# Staff Report

## Middle Housing Land Division (Tentative Partition Plat)

PA-04-24

May 8, 2024

Sheet **C1.1**  
 SCALE: SEE BARSCALE

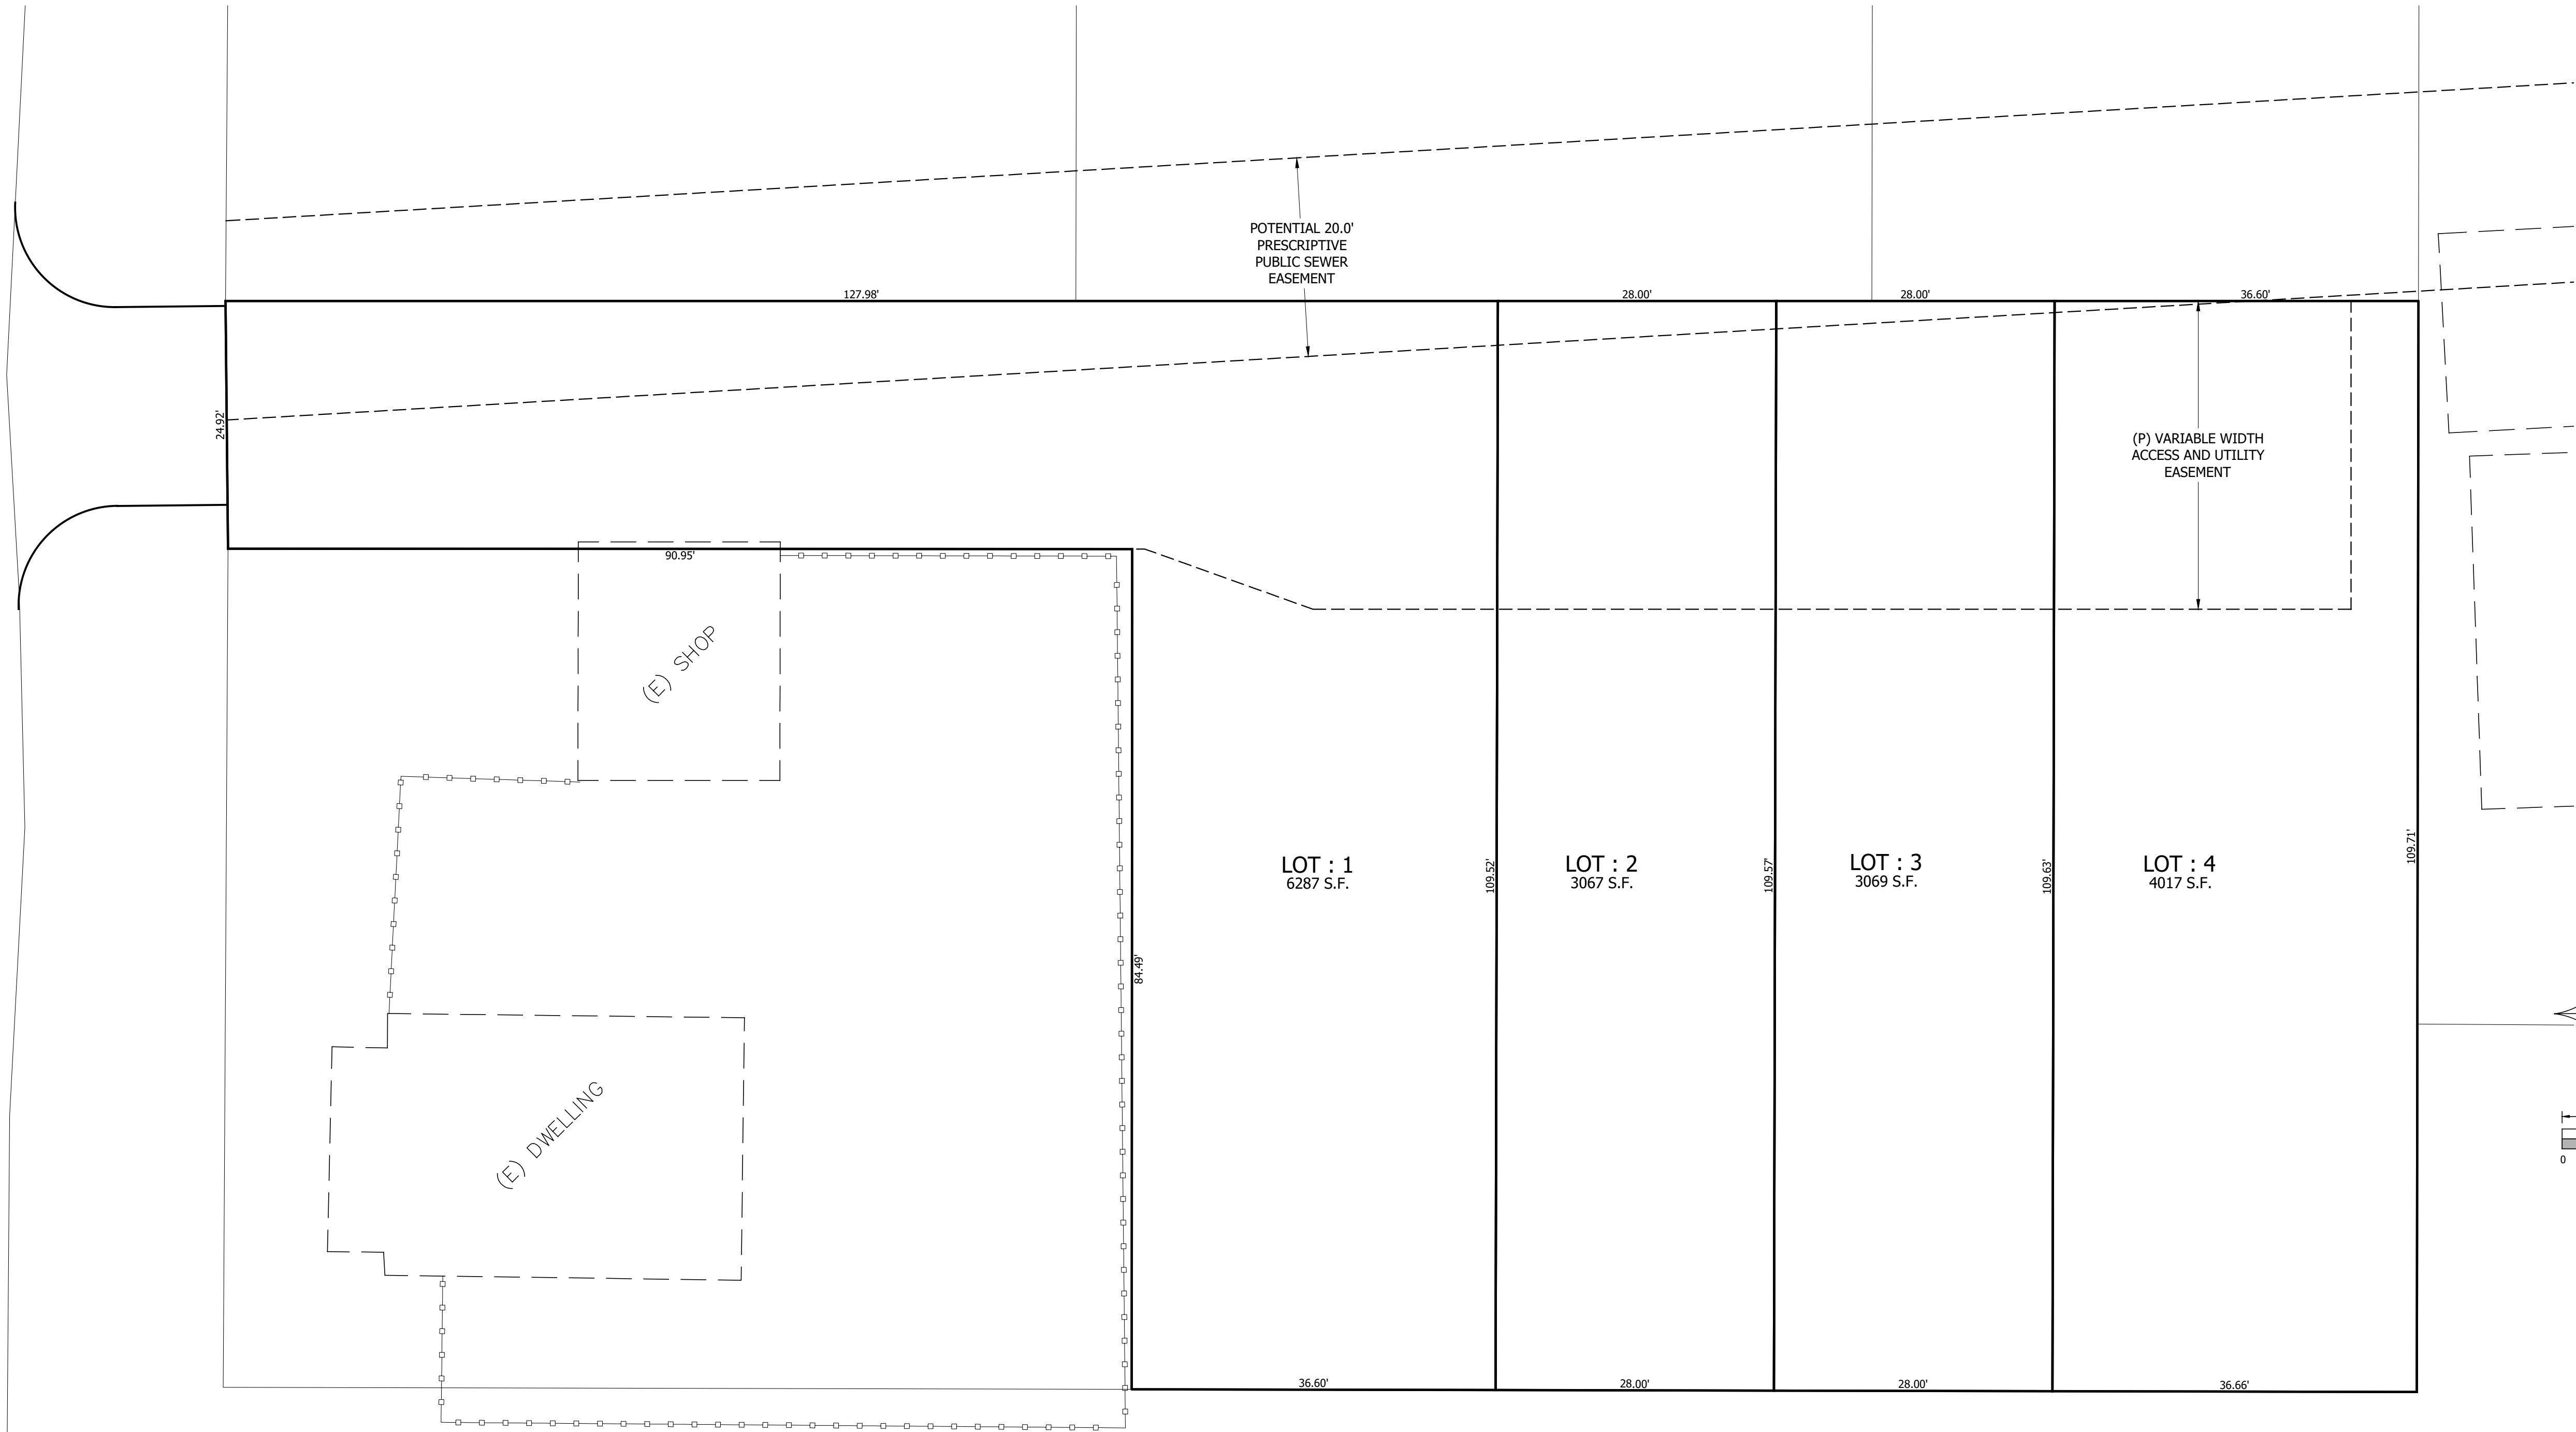
- 3.1 The applicant has proposed a utility easement for the placement, access, and servicing of utilities for each dwelling unit on the site.
- 3.2 The applicant has proposed an access easement for access to each dwelling unit, which includes pedestrian access to the public road and driveway access. Prior to recording the final plat, a 36-inch-wide emergency access easement benefiting lots 2 and 3 shall be provided on the adjacent lot(s) to provide emergency egress for sleeping rooms to comply with the Oregon Residential Specialty Code.
- 3.3 All of the adjoining properties have independent access to a public street, and the proposed partition will not impact the access of adjoining properties.
- 3.4 The applicant proposes to record the portion of the 20-foot-wide public sewer easement located on the subject property.

- Condition 5 Prior to recording the final plat, a 36-inch-wide emergency access easement benefiting lots 2 and 3 shall be provided on the adjacent lot(s) to provide emergency egress for sleeping rooms to comply with the Oregon Residential Specialty Code.

- Condition 5 Prior to recording the final plat, a 36-inch-wide emergency access easement benefiting lots 2 and 3 shall be provided on the adjacent lot(s) to provide emergency egress for sleeping rooms to comply with the Oregon Residential Specialty Code.

Sheet **C1.2**

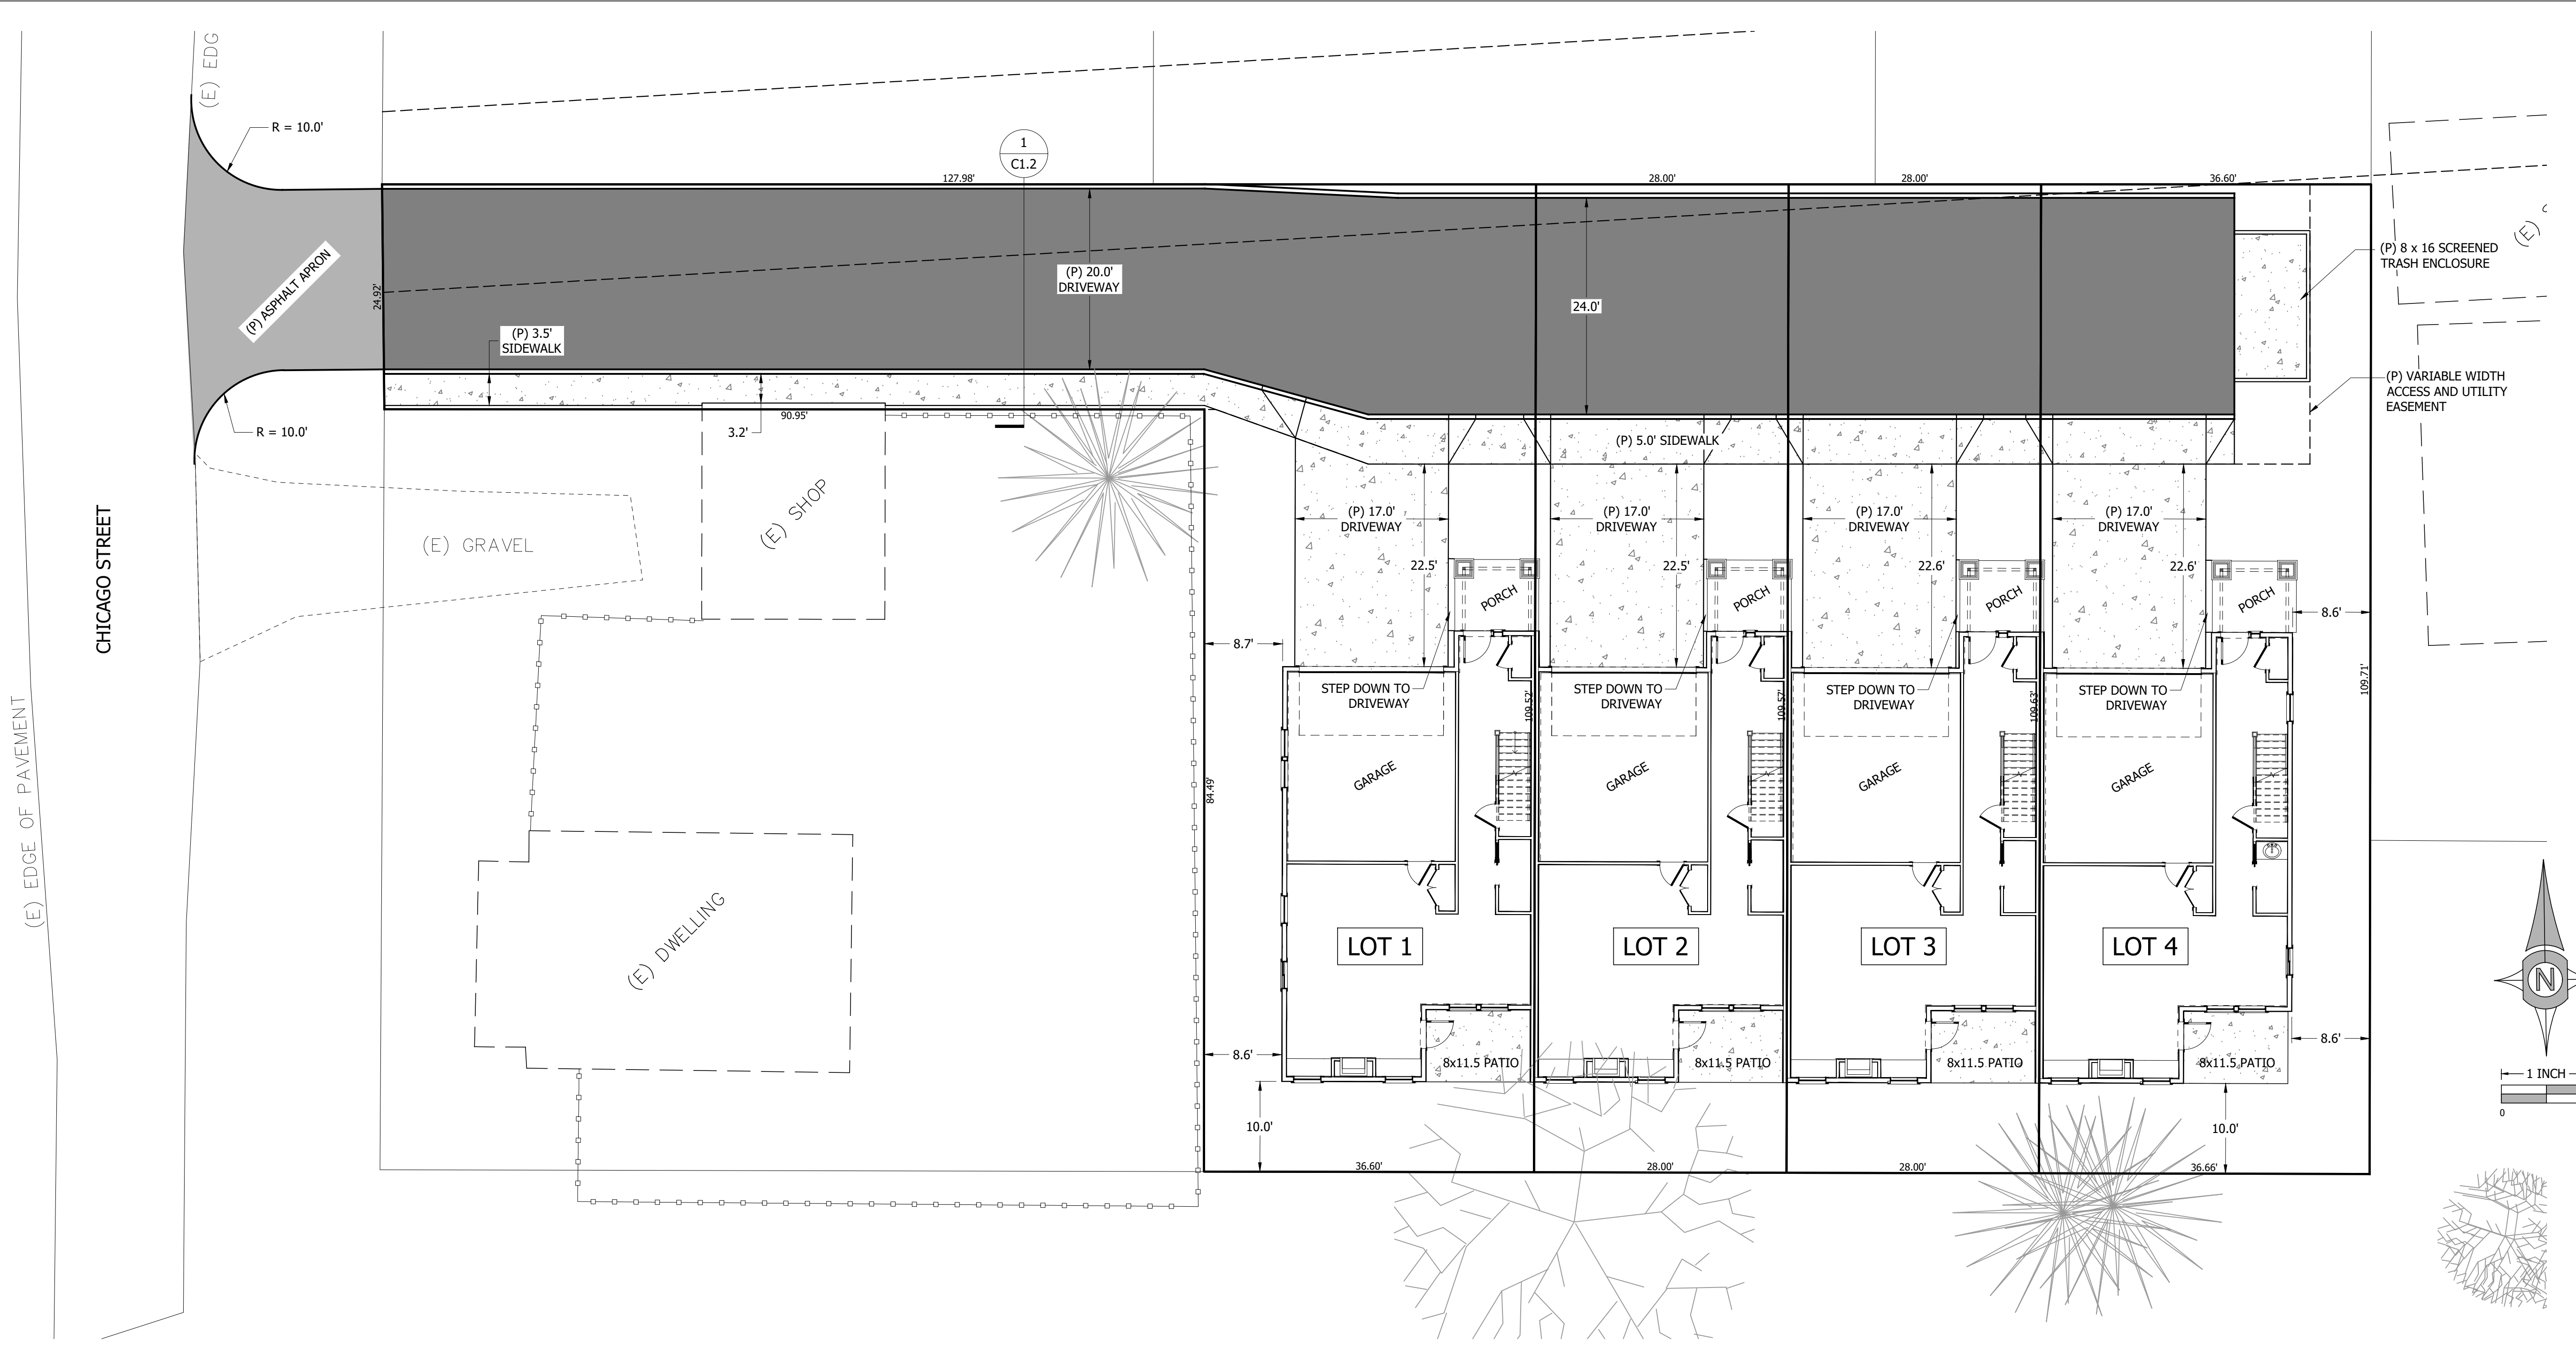
- 2.4 The applicant's preliminary utility plan shows new sanitary sewer laterals off the public sanitary sewer main along the northern property line to serve each lot of the proposed subdivision. The sewer laterals are shown to be located within a private access and utility easement. Before any work is done on or around a public sanitary sewer main the applicant must obtain a Site Improvement Permit from the City's Engineering Division.

- 2.12 The applicant's preliminary utility plan shows new water services installed off the water main in Chicago Street to serve each lot of the subdivision. The water services for each lot are shown to be located within a private access and utility easement. The applicant must obtain a Water Meter Permit from the City's Engineering Division for installation of water services.

- 2.19 The applicant has submitted a preliminary drainage plan that shows the extension of public storm drainage system in Front Avenue NE to the subject property and a private detention system. The on-site storm system is shown to be located within a private access and utility easement. Final design details for these storm drainage facilities will be reviewed in conjunction with the subdivision. Before any work is done on or around a public storm drainage main the applicant must obtain a Site Improvement Permit from the City's Engineering Division.

- 2.1 Public sanitary sewer and water are available to serve the proposed development. The applicant must install water and sewer services to serve each of the proposed lots. The applicant proposes an access and utility easement for all services.

- 2.3 The applicant must extend public storm drainage facilities in Chicago Street NE to the site from Front Avenue NE to serve the future development.

- Condition 1 Prior to approval of the final subdivision plat, the applicant must construct public storm drainage improvements from Front Avenue NE to the southern boundary line of the subject property in Chicago Street NE. In addition, the applicant must construct stormwater detention facilities that comply with the City's Engineering Standards.

- Condition 2 Prior to approval of the final subdivision plat, the applicant must dedicate the portion of the 20-foot public sanitary sewer easement located on the subject property to the City.

- Condition 3 Prior to approval of the final subdivision plat, the applicant must obtain a water meter permit for installation of water services to serve each lot of the subdivision.
